Road Safety Audit Stage 1

**Bartons Road Access, S278 and S38
Works, Havant**

RSA Report Ref.	Version	Date of Issue
RSA1123	Final	21/01/2026

Designer's Response to the Stage 1 Safety Audit Rev B

Scale	1:250@A1	Date	Dec 2025	Designed	DA
Drawn	DA	Checked	SW	Approved	-
Job No	24-097	Drawing No	24-097/017	Rev	B

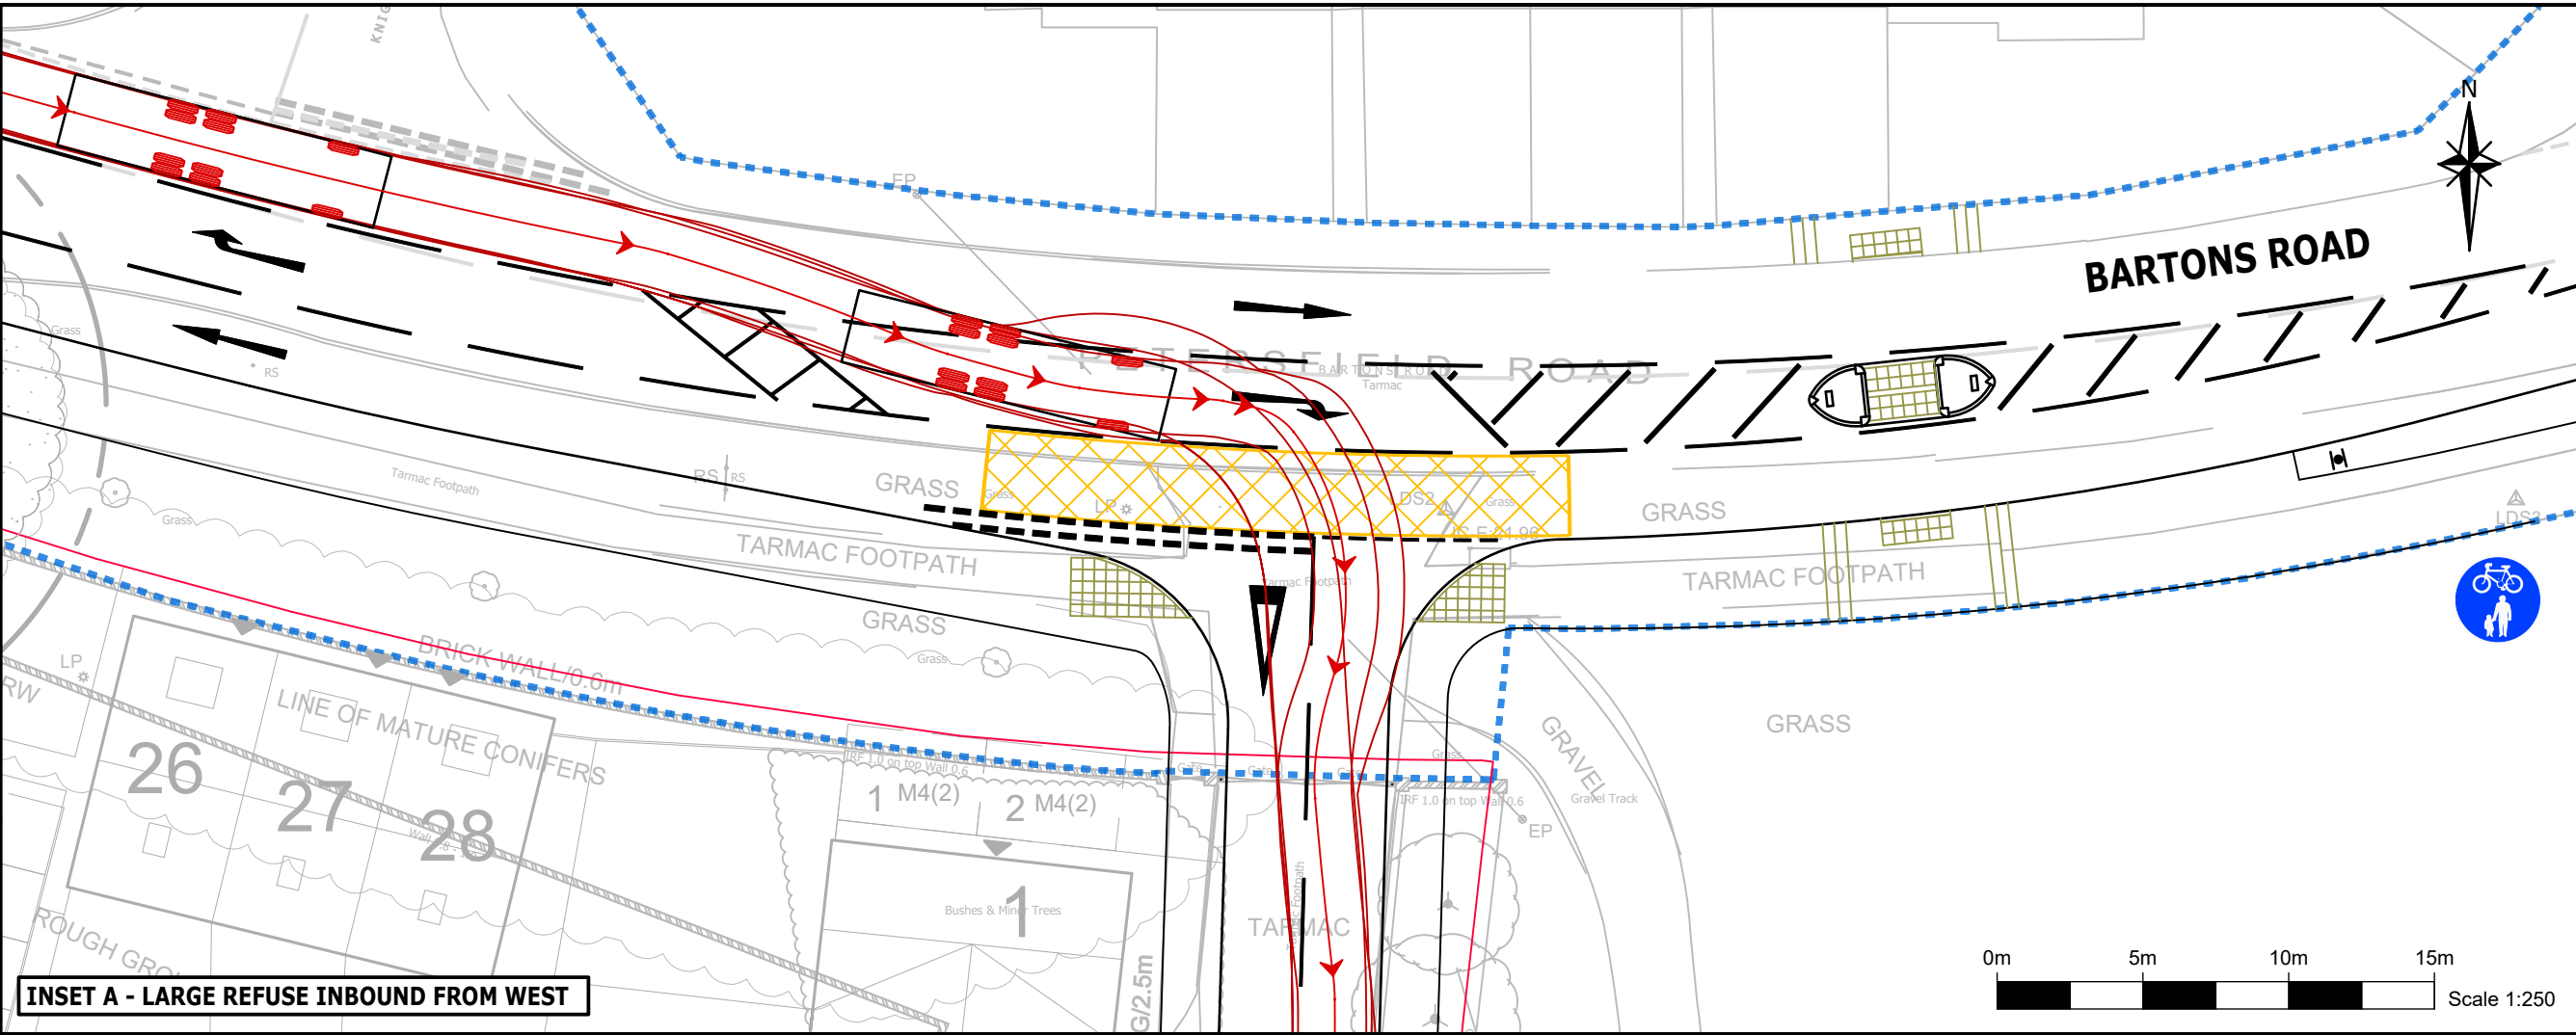
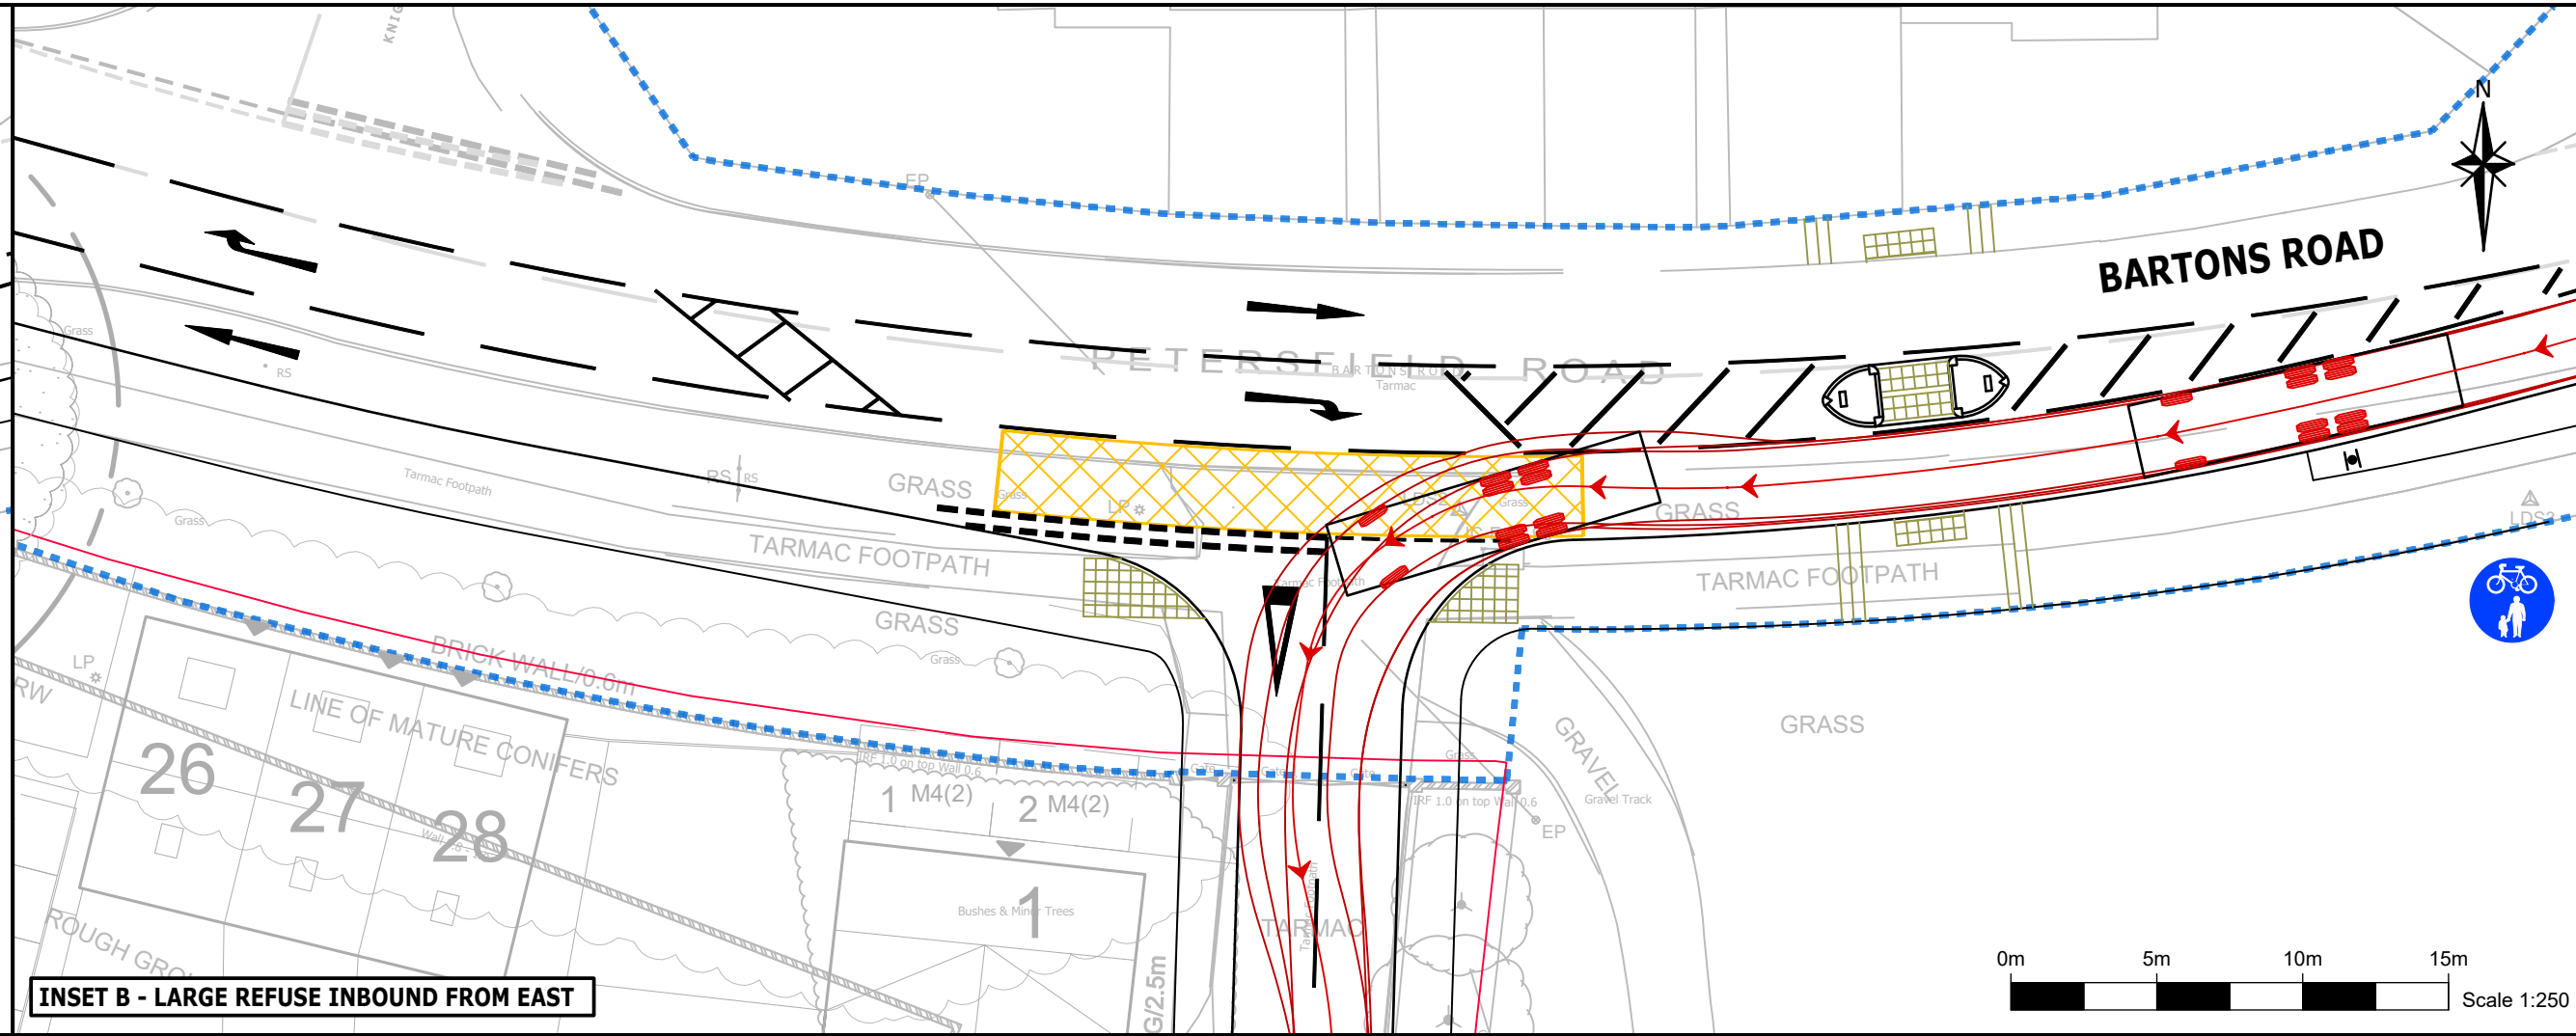
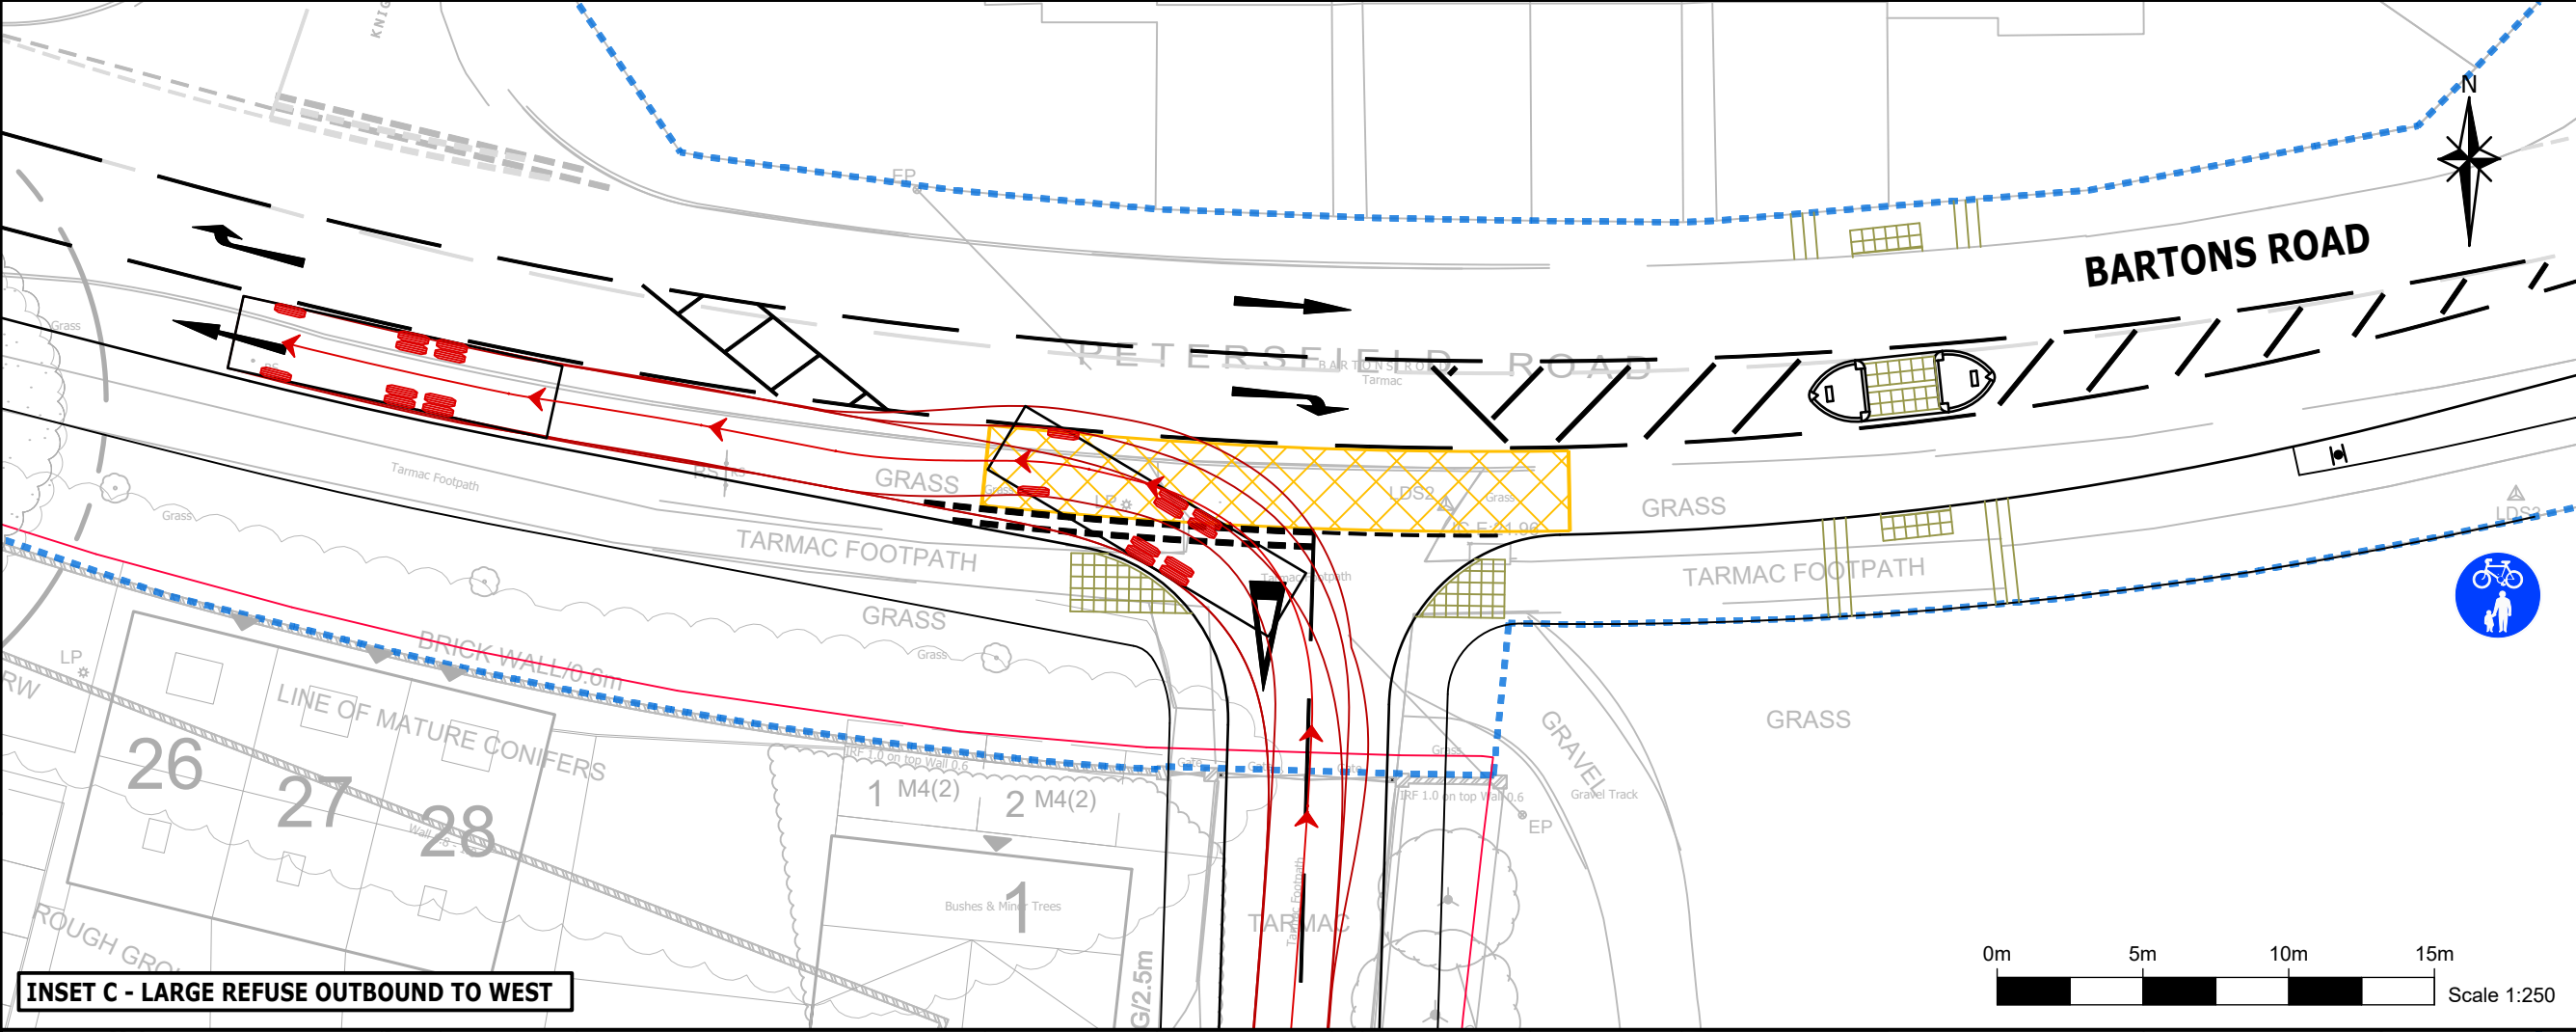
The existing dropped kerbs at this crossing point are not opposite one another (photo 4). If the tactile paving is installed in the location shown on the drawing, without altering the dropped kerbs on the northern side, blind pedestrians crossing from south to north will be guided into the transition and full height kerbs, increasing their risk of trips and falls.

On the north side of Bartons Road the kerbs should be dropped adjacent to the proposed tactile paving and the existing dropped kerbs raised to full height away from the crossing point.

Blind and partially sighted pedestrians alighting from the bus should be reminded that they are walking onto a shared cycle/footway as they pass the gaps within, and to the side of, the bus shelter (photo 5), so that they can orientate themselves on the facility to minimise their risk of collisions with cyclists: blind pedestrians are taught to follow the edge of a shared cycle footway rather than the centre when they are entering a footway.

Corduroy paving should be installed within, and adjacent to, the bus shelter abutting the northern edge of the cycle/footway.

On the northern side of this uncontrolled crossing the tactile paving will coincide with the dropped kerbs for the uncontrolled crossing of Forestside Avenue. Pedestrians crossing Forestside Avenue may mistakenly use the new tactile paving for the Bartons Road crossing and encounter a full height kerb on the eastern side of Forestside Avenue, increasing their risk of trips and falls.

The tactile paving for the proposed crossing of Bartons Road should not coincide with the dropped kerbs for the crossing of Forestside Avenue. If necessary, the uncontrolled crossing of Forestside Avenue should be relocated slightly further away from Bartons Road, with new dropped kerbs and tactile paving.

An existing lamp column, currently in the verge (photo 6), is likely to be within the shared cycle/footway increasing the risk of cyclists colliding with it.

The lamp column should be relocated away from the cycle/footway i.e. near the carriageway of Bartons Road.

Blind and partially sighted pedestrians entering the cycle/footway from the church forecourt need to be reminded that they are entering a shared facility so that they can orientate themselves on the facility to minimise their risk of collisions with cyclists.

Corduroy paving should be installed at the edge of the cycle/footway abutting the top of the flight of steps up from the church forecourt.

There is a risk that users of the proposed refuge island on Bartons Road may step directly onto the shared cycle/footway without warning. Clear warnings are required for blind and partially sighted pedestrians to indicate entry into a shared facility, enabling safe orientation and reducing collision risk with cyclists.

Corduroy paving should be installed either side of the footway close to the pedestrian refuge island.

3.9	<p>Problem</p> <p>Location: I – The uncontrolled pedestrian crossing of Barton Road, just west of Witchampton Close (Dwg. 24-097/017).</p> <p>Summary:</p> <p>Risk of pedestrian trips and falls on the transition kerbs and full height kerbs.</p> <p>The existing dropped kerbs at this crossing point are not opposite one another (photo 4). If the tactile paving is installed in the location shown on the drawing, without altering the dropped kerbs on the northern side, blind pedestrians crossing from south to north will be guided into the transition and full height kerbs, increasing their risk of trips and falls.</p>	<p>Recommendation:</p> <p>On the north side of Bartons Road the kerbs should be dropped adjacent to the proposed tactile paving and the existing dropped kerbs raised to full height away from the crossing point.</p>	<p>Agree:</p> <p>Dropped kerb to be provided adjacent to the proposed tactile paving and the existing dropped kerbs raised to full height away from the crossing point, as illustrated in Drawing 24-097/017 Rev B.</p>

3.10	<p>Problem</p> <p>Location: J – The westbound bus stop and shelter (Dwg. 24-097/017).</p> <p>Summary:</p> <p>Risk of collision between blind pedestrians and cyclists on the shared facility.</p>	<p>Recommendation:</p> <p>Corduroy paving should be installed within, and adjacent to the bus shelter abutting the northern edge of the cycle/footway.</p>	<p>Agree:</p> <p>Corduroy paving to be provided within, and adjacent to the bus shelter abutting the northern edge of the cycle/footway, as illustrated in Drawing 24-097/017 Rev B.</p>

3.11	<p>Problem</p> <p>Location: K – Uncontrolled pedestrian crossing just west of Forestside Avenue (Dwg. 24-097/017).</p> <p>Summary:</p> <p>Risk of pedestrian trips and falls.</p> <p>On the northern side of this uncontrolled crossing the tactile paving will coincide with the dropped kerbs for the uncontrolled crossing of Forestside Avenue. Pedestrians crossing Forestside Avenue may mistakenly use the new tactile paving for the Bartons Road crossing and encounter a full height kerb on the eastern side of Forestside Avenue, increasing their risk of trips and falls.</p>	<p>Recommendation:</p> <p>The tactile paving for the proposed crossing of Bartons Road should not coincide with the dropped kerbs for the crossing of Forestside Avenue. If necessary, the uncontrolled crossing of Forestside Avenue should be relocated slightly further away from Bartons Road, with new dropped kerbs and tactile paving.</p>	<p>Agree:</p> <p>New dropped kerbs and tactile paving to be provided to relocate the existing uncontrolled crossing of Forestside Avenue, as illustrated in Drawing 24-097/017 Rev B.</p>

3.12	<p>Problem</p> <p>Location: L – Southern side of Bartons Road opposite Forestside Avenue (Dwg. 24-097/017).</p> <p>Summary:</p>	<p>Recommendation:</p> <p>The lamp column should be relocated away from the cycle/footway i.e. near the carriageway of Bartons Road.</p>	<p>Agree:</p> <p>Proposed footway to have localised narrowing if required to prevent risk of collision with existing lamp column as illustrated in Drawing 24-097/017 Rev B.</p>

3.13	<p>Problem</p> <p>Location: M – Southern side of Bartons Road at the steps up from the church (Dwg. 24-097/017).</p> <p>Summary:</p> <p>Risk of collisions between blind pedestrians and cyclists on the shared facility.</p> <p>Blind and partially sighted pedestrians entering the cycle/footway from the church forecourt need to be reminded that they are entering a shared facility so that they can orientate themselves on the facility to minimise their risk of collisions with cyclists.</p>	<p>Recommendation:</p> <p>Corduroy paving should be installed at the edge of the cycle/footway abutting the top of the flight of steps up from the church forecourt.</p>	<p>Agree:</p> <p>Corduroy paving to be provided, as shown in Drawing 24-097/017 Rev B.</p>

3.14	<p>Problem</p> <p>Location: N – Southern side of Bartons Road at the proposed pedestrian refuge island (Dwg. 24-097/017).</p> <p>Summary:</p> <p>Risk of collisions between blind pedestrians and cyclists on the shared facility.</p>	<p>Recommendation:</p> <p>Corduroy paving should be installed either side of the footway close to the pedestrian refuge island.</p>	<p>Agree:</p> <p>Corduroy paving to be provided, as shown in Drawing 24-097/017 Rev B.</p>
